Intersection ID: 19118	Main Street: BEVERWYCK_RD	Cross Street: COLONY_RD	Location:	NE
ADA ID: 32B89698C518	Ramp Type: PerpDiag	Initial Pass/Fail: Pass	Overall Compliance: No	Severity Score: 10.25

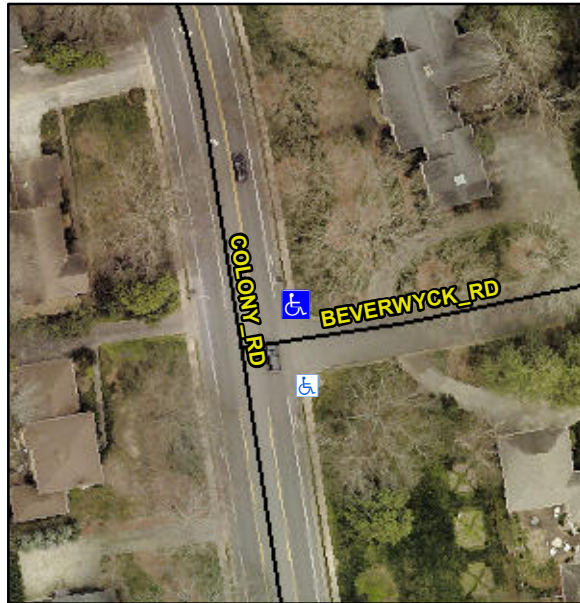
**R304.5.3, R304.2.1, R304.2.2-Perp,
R304.3.2-Para**

Compliance	Description	Data	Compliance	Description	Data
N/A	Ramp Length (in)	65.0	Yes	Ramp Slope (%)	5.3
Yes	Ramp Width (in)	49.0	No	Ramp XSlope (%)	3.6
N/A	Flare Type LT	Sloped	N/A	Flare Type RT	N/A
N/A	Flare Slope LT (%)	6.4	Yes	Flare Slope RT (%)	7.7
N/A	Flare Traversable LT?	Yes	N/A	Flare Traversable RT?	Yes
No	Landing Length (in)	N/A	Yes	DWS Provided?	Yes
No	Landing Width (in)	N/A	Yes	DWS Contrast?	Yes
No	Landing Slope (%)	N/A	Yes	DWS Length (in)	24.5
No	Landing X Slope (%)	N/A	Yes	DWS Full Width?	Yes
N/A	Landing Curb? (Y/N)	No	Yes	DWS Offset (in)	1.0
N/A	Shared Landing?	N/A			
Yes	Gutter Ponding?	No	Yes	Gutter Slope (%)	3.3
Yes	Gutter Lip Ht (in)	0.0	Yes	Gutter X Slope (%)	1.0
N/A	Painted X Walk1?	No	N/A	Painted X Walk2?	No
	X Walk 1 Direction	To W		X Walk 2 Direction	To S
N/A	X Walk 1 Width (in)	N/A	N/A	X Walk 2 Width (in)	N/A
	X Walk 1 Slope (%)	6.4		X Walk 2 Slope (%)	4.2
	X Walk 1 X Slope (%)	3.6		X Walk 2 X Slope (%)	0.1

Remove & Replace Curb Ramp With Two New Directional Ramps or Equivalent.
